M25 Junction 28 Improvements TR010029

8.1 Statement of Common Ground with the Environment Agency

M25 junction 28 scheme Development Consent Order 202[x]

This Statement of Common Ground has been prepared and agreed by (1) Highways England Company Limited and (2) the Environment Agency.

Figure 1
Initial assessment of effects of M25-J28
improvement works on water environment
15/04/19, v0.3, Drawn by MHE
STATUS - uncontrolled work in progress

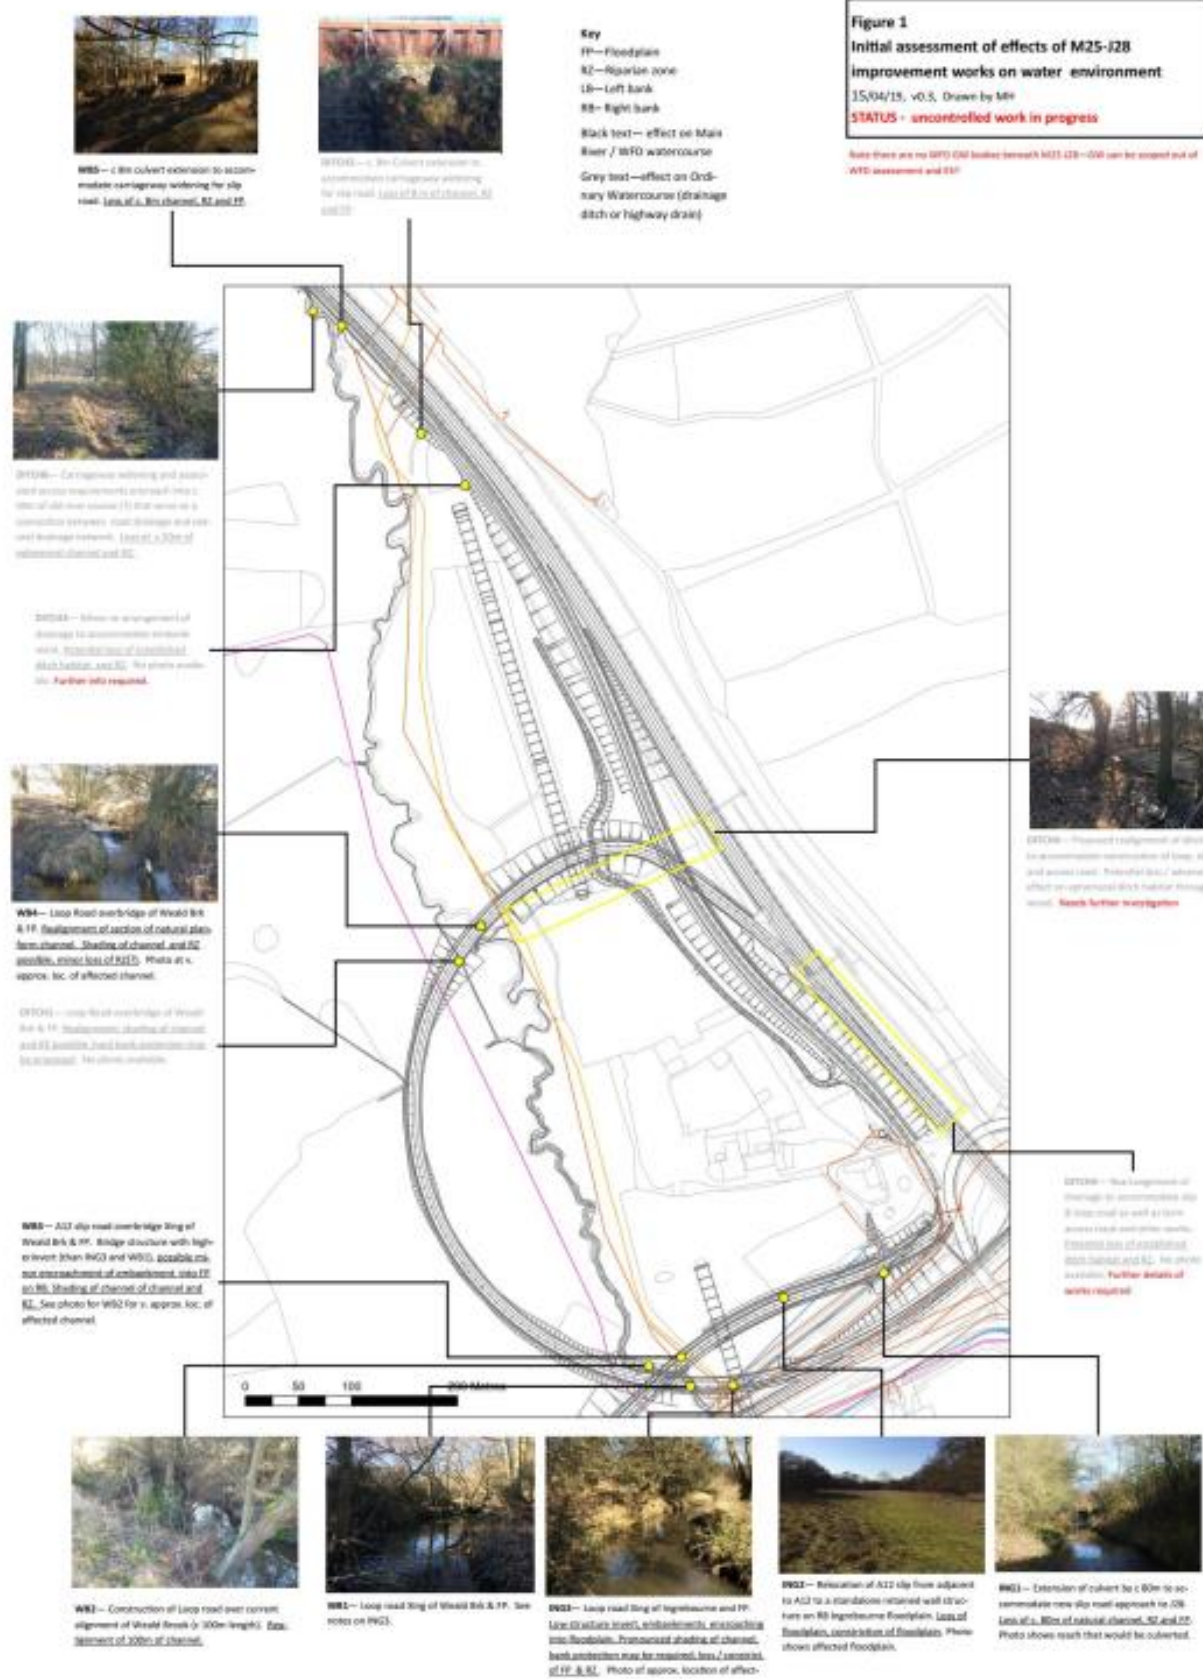
ING2	Moving of A12 slip	<ul style="list-style-type: none"> ○ EA interested in height of retaining wall (shading effect), and connection for wildlife into the corral created by the slip road. Atkins need to limit shade and ensure connectivity within design.
ING3	Loop Rd Xing of Ingrebourne and FP	<ul style="list-style-type: none"> ○ Design of both structures severely controlled by constraints beyond water environment (principally utilities). Atkins are homing in on a design that should meet flood risk requirements (see below) and minimise effect on river. So, flood freeboard and 8m between bank edge and bridge abutment should be provided. However, bridges will inevitably shade watercourse and riparian zone. Also, very likely that abutments will encroach into floodplain. ○ EA happy with FCA mitigation for floodplain loss and will comment on compensation measures proposed for shading (tree works and wetland habitat creation on Weald Brook).

WB1	Southern loop Rd Xing of Weald Brk and FP	
WB2	Section of loop road adjacent to Weald Brk	<ul style="list-style-type: none"> ○ Loop road alignment (forced by safety, environment and golf course constraints) now falls over a length of the Weald Brook. EA generally happy with proposed mitigation – restoration of a similar length of existing straightened channel to more natural form.
WB3	A12 slip road overbridge	<ul style="list-style-type: none"> ○ Relatively high and wide structure that should span full floodplain. At present not seen as significant effect on water environment.
WB4	Northern loop Xing of Weald	<ul style="list-style-type: none"> ○ Shift in bridge location (from DF2 location) forced by safety, environment (protection of woodland with potential veteran trees) and golf course constraints means that existing planform cannot be protected in scheme design.

Scheme component (see fig. 1)	Name	Discussion points
	Brook and FP	<ul style="list-style-type: none"> EA asked if Atkins can investigate retaining the upstream two meanders in the proposed realignment (Action [REDACTED] – look into this design change) EA generally happy with proposed mitigation – restoration of a similar length of existing straightened channel to more natural form
WB5	Culvert extension on M25 Weald Brook Xing	<ul style="list-style-type: none"> Discussed briefly. Principles set out in "Initial thoughts from EA" for ING1 apply (though obviously at a much smaller scale, given the 8m extension here). (Action [REDACTED] – update mitigation, given that existing proposals are not adequate – can probably be included into proposed restoration elsewhere on Weald Brook)
Ditches		Not discussed at meeting (of lesser significance than effects on main river)

Figure 3 Action straw doll conceptual design schematic

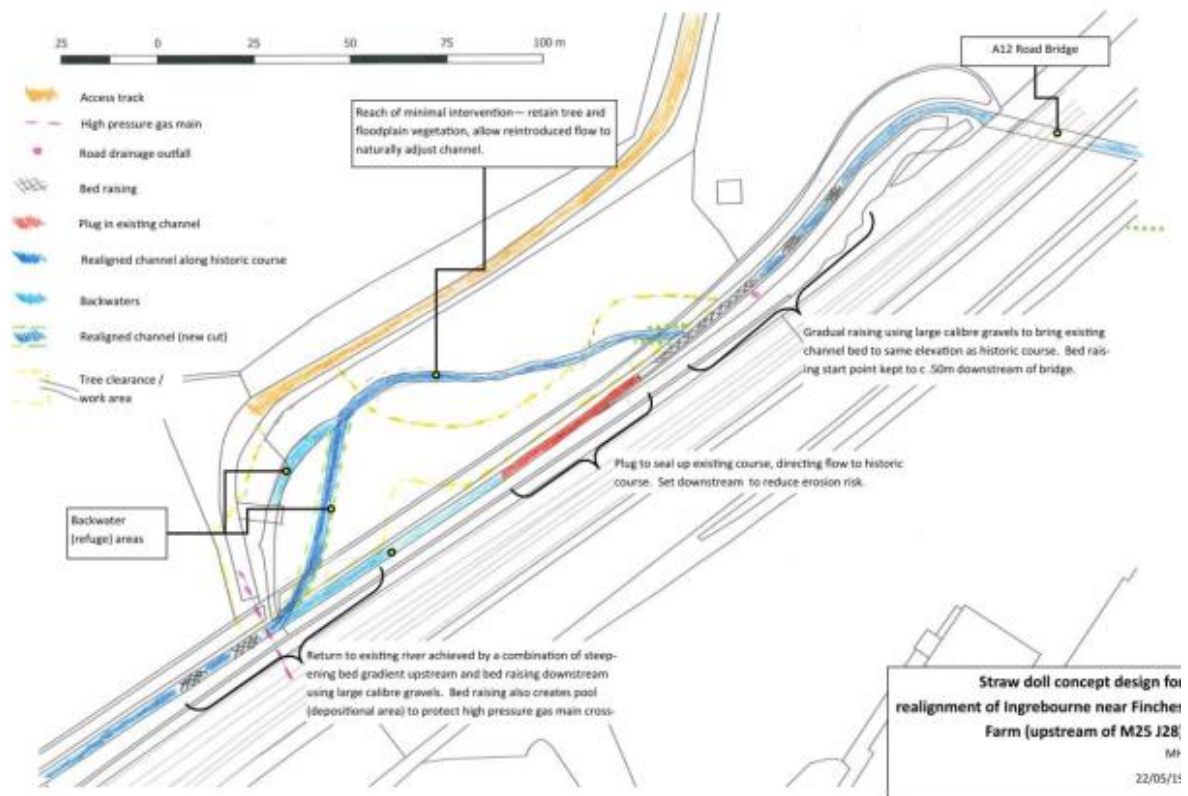
A conceptual design based on discussions during the field visit presented in Figure 3. This is intended as a starting point and a trigger for discussion on determining feasibility of this intervention

**Potential works identified
during telcon of 11/2/20
(locations approximate)**
v0.1, 11/2/20

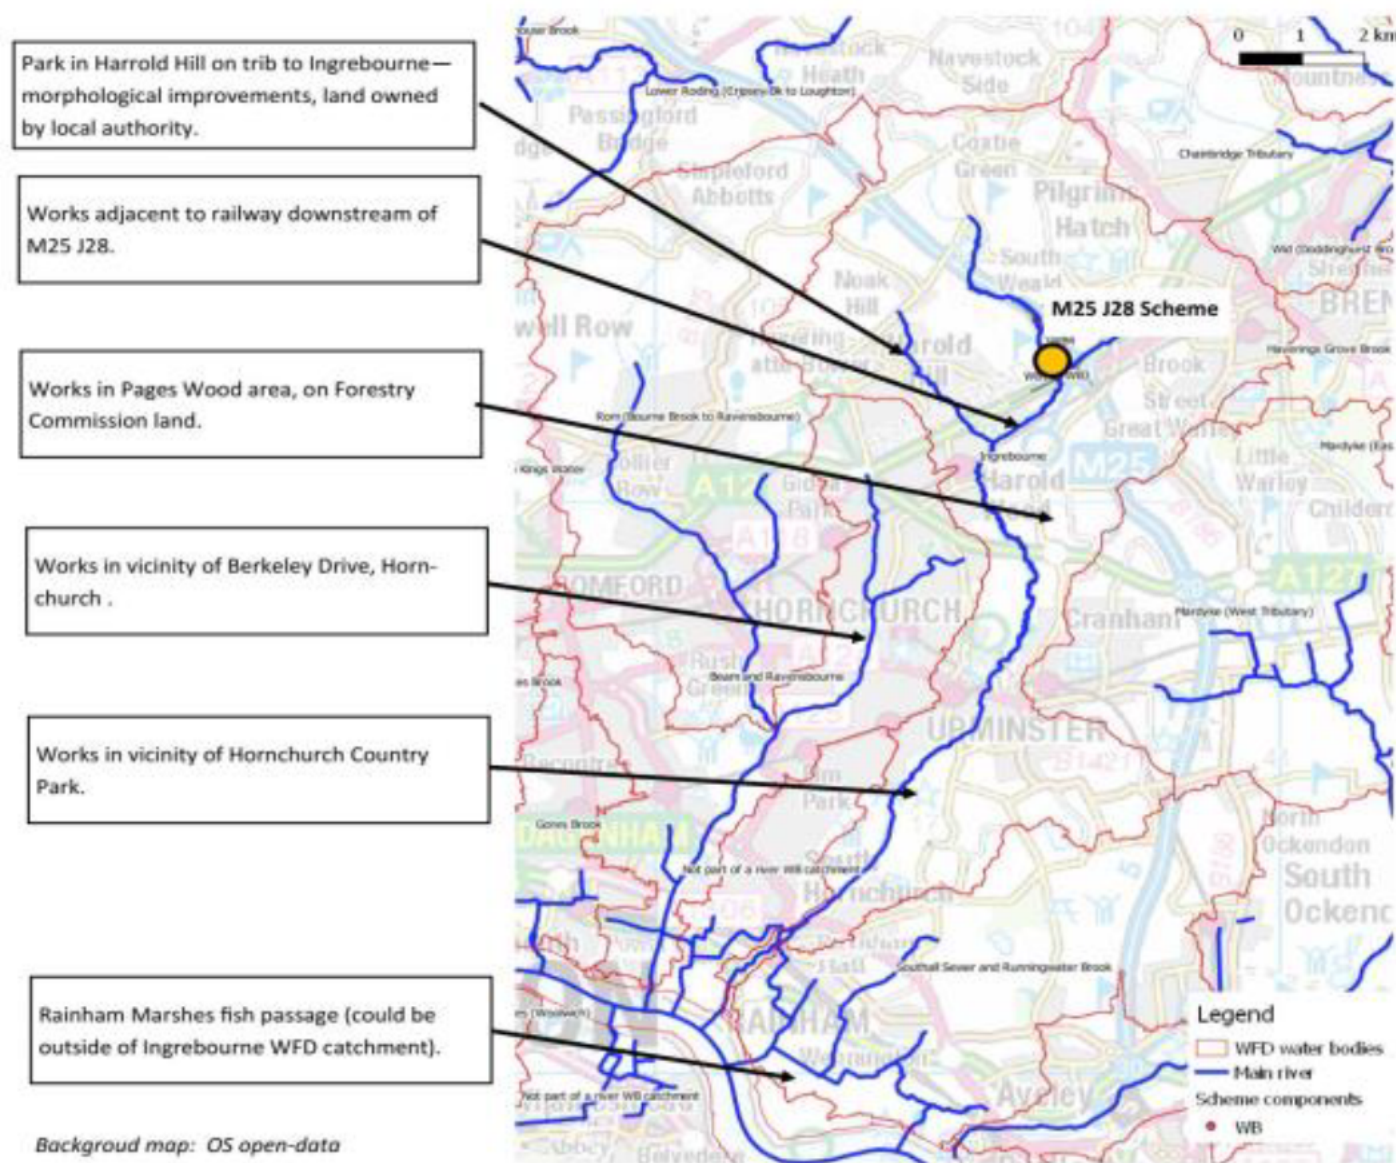
3.	<p>Discussion on potential locations of measures</p> <p>Location of potential measures (called works in this note) within Ingrebourne WFD water body identified during telcon show on attached plan (rough locations).</p> <p>EA planning windscreen survey / walkover of key areas of Ingrebourne catchment to identify potential river / floodplain improvement works – some could be candidate sites for off-site compensation for J28 Scheme.</p> <p>Local Authority 'forum' being organised for the J28 Scheme to bring together appropriate specialists from the J28 project team and local authorities to address key issues such as consenting. Off-site compensation will be included as a topic for the forum. EA welcome to attend the forum, particularly on this issue, either in person or by telcon. Provisional date 3rd March 2020.</p> <p>Landowner appetite for river improvement works will always be a fundamental constraint – this risk can be managed by identifying works on land owned by aligned partners (e.g. local authorities and Forestry Commission) and identifying multiple river improvement works, in the expectation that some will fall by the wayside because landowners are unable to provide support.</p> <p>In summary – EA team were positive about being able to identify a sufficient number of candidate river improvement works within the Ingrebourne WFD body but needed some time to investigate further before being able to commit to this.</p>
